UNITED STATES PATENT AND TRADEMARK OFFICE

10/658,472

Hidekazu Miyairi

Office Action Summary

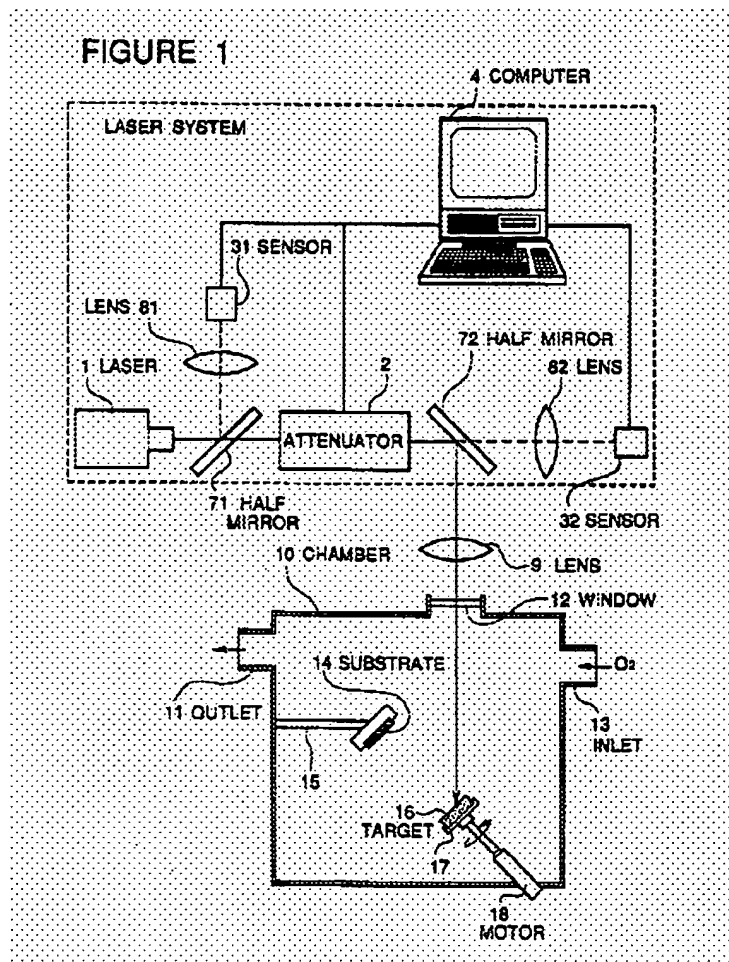
Claim 2 is rejected under 35 U.S.C. 102(b) as being clearly anticipated by Nagaishi et al (US Patent No. 5544182). Nagaishi discloses a laser apparatus comprising a laser oscillator 2; a light amount adjuster 2 for adjusting an energy of an incident laser beam by changing a transmittance thereof; a driver 4 for controlling the transmittance of the light amount adjuster 2; an entrance side optical system 71 for sampling a part of the laser beam that enters the light amount adjuster 2; a first electric signal generator 31 for generating a first electric signal that contains as a data an energy fluctuation of the laser beam that enters the light amount adjuster

using a part of the laser beam sampled by the entrance side optical system 71; an exit side optical system 72 for sampling a part of a laser beam of which the energy has been adjusted by the light amount adjuster; a second electric signal generator 32 for generating a second electric signal that contains as a data an energy fluctuation of the laser beam of which the energy has been adjusted by the light amount adjuster using the part of the laser beam sampled by the exit side optical system; and a signal processing unit 4 for subjecting the first electric signal and the second electric signal to a signal processing to grasp a state of the energy fluctuation of the laser beam that enters the light amount adjuster as well as a state of the energy fluctuation of the laser beam whose energy has been adjusted by the light amount adjuster. It is noted that Nagaishi discloses the computer 4 which controls the light amount adjuster (attenuator) so therefore it is inherent to have an attenuator driver.

With respect to claims 1, Nagaishi discloses in Fig. 1 a laser apparatus comprising a laser oscillator 1; an electric signal generator 71 sampling a part of a laser beam emitted from the laser oscillator; an electric signal generator 31 for generating an electric signal that contains an energy fluctuation of the laser beam as a data using the part of the laser beam sampled; a light amount adjuster 2 for adjusting an energy of the laser beam emitted from the laser oscillator by changing a transmittance thereof; and a signal processing unit 4 for subjecting the electric signal to a signal processing except for explicitly teaching to calculate a frequency, an amplitude, and a phase of the energy fluctuation of the laser beam. However, it is believed that the computer is capable of calculating a frequency, amplitude, and a phase of the energy fluctuation of the laser beam by
